SERVICE BULLETIN 350

SUBJECT: Extended Delivery Detector Cover Kit Installation

MODELS: RVV 500 ADA (Coca-Cola)

KIT NUMBER	KIT DESCRIPTION
337042	Extended Delivery Detector Cover Kit

Figure 1.

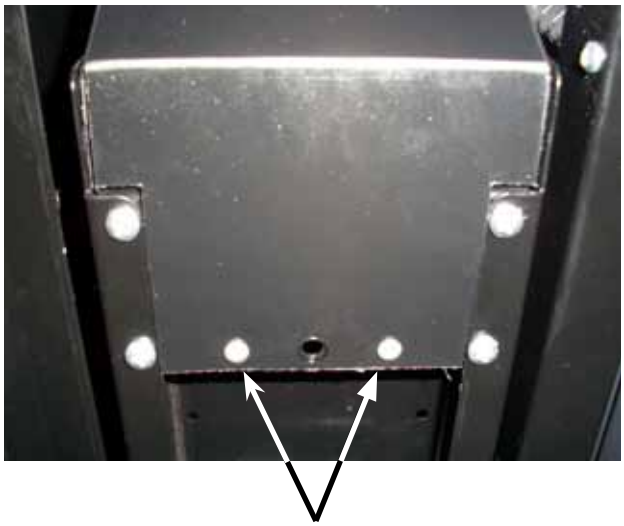
Drill out these two rivets with a 1/8" (3 mm) bit.

1. Remove power by unplugging the vender's power cord from the AC voltage source (wall outlet).
2. Using a 1/8" (3 mm) bit, drill out the rivets that secure the existing detector cover. *(See Figure 1.)* Remove the cover and discard.
3. Install the new extended cover. Use the two screws from the kit to secure the extended cover in the holes where the previous rivets were installed. The wings of the cover *(see Figure 2)* should be inside the flanges of the top of the port box (see Figure 3). The end of the cover should be tucked under the screws shown in Figure 4.
4. Restore power by plugging the vender's power cord into the AC voltage source (wall outlet).

Figure 3.

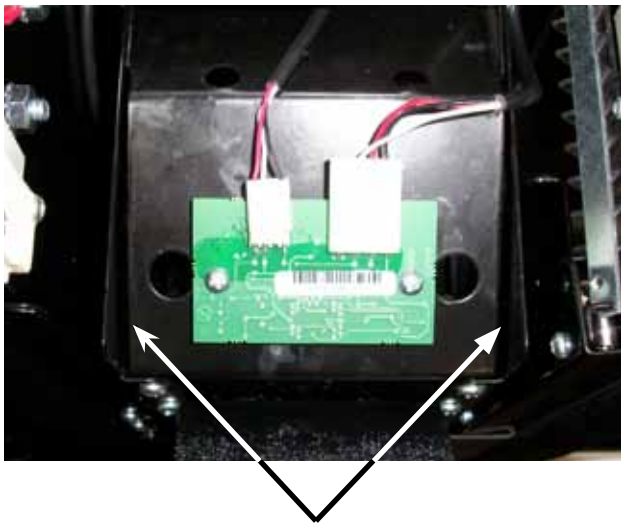
The wings of the extended cover should be folded *inside* these two flanges on the top of the port box.

Figure 4.

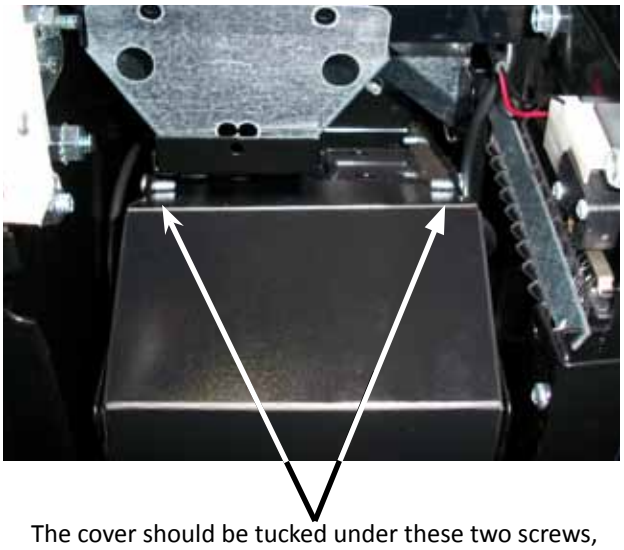
The cover should be tucked under these two screws, as shown.
